SERVICE TECHNICAL INFORMATION

ONE POINT REPAIR

UTSUNOMIYA, February 28, 1995
REF. NO. : SI-94-051
CUSTOMER RELATIONS & SERVICE DIV.

MODEL : AM - F1
SUBJECT : ALC characteristic change
SYMPTOM : The customer indicates such things as level fluctuation and sound distortion during analog REC (LINE, MIC). In such cases, perform the following remedy in order to change the ALC (auto level control) characteristic.
However, explain to the customer that this ALC is set on the premise of being used in a long running mode (monophonic recording), and to some degree similar symptoms will occur even after performing the following remedy.

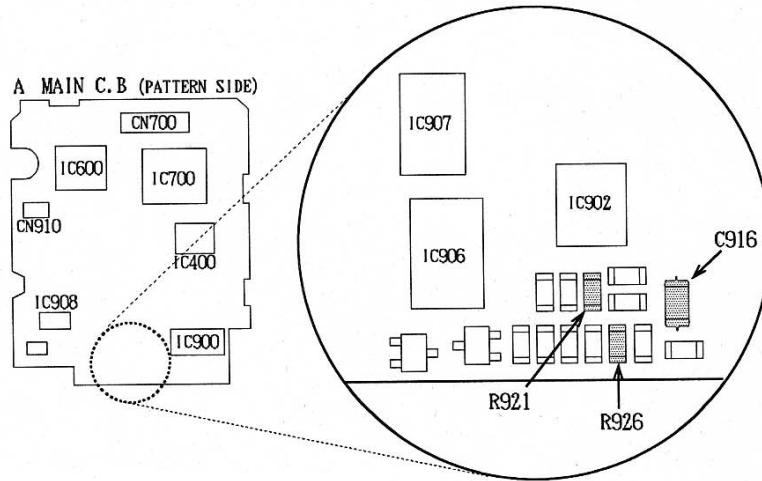
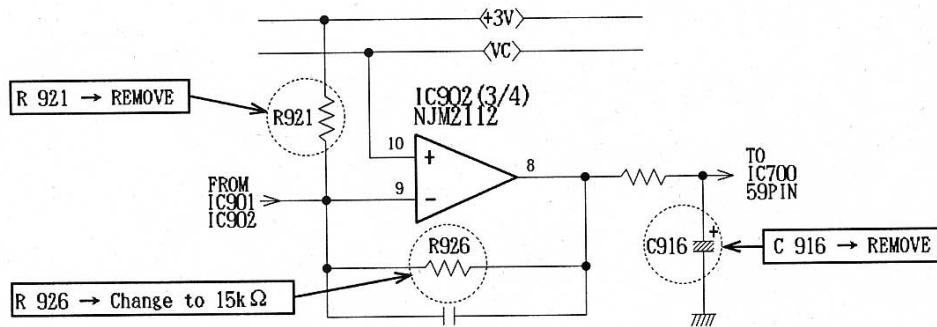
REMEDY : Remove the parts shown below and change the constant.

Ref. No.	Part Name	Part No.
R926	C-RES, U 15K-1 / 16W	88-108-153-080
